ADDENDUM # 1

McLaughlin Youth Center Air Handling Unit Upgrades ANC 15-04C

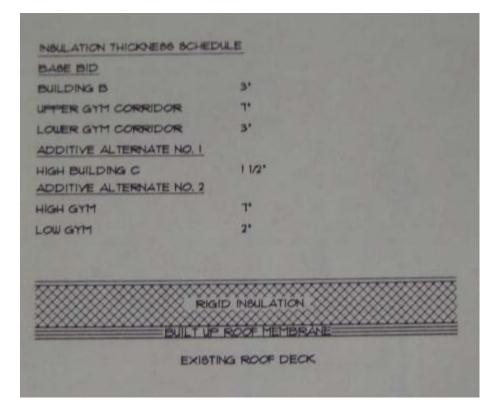
AD1-1. The existing roof above where the condensing units are being installed under Additive Alternate #2 is an IRMA roof installed in 1993. No roof warranty is in place. Below is an excerpt from those drawings on the roof construction. Area of construction is "Building B". Contractor is to assume that there is no asbestos in the roof but is to complete a materials test prior to construction to verify.
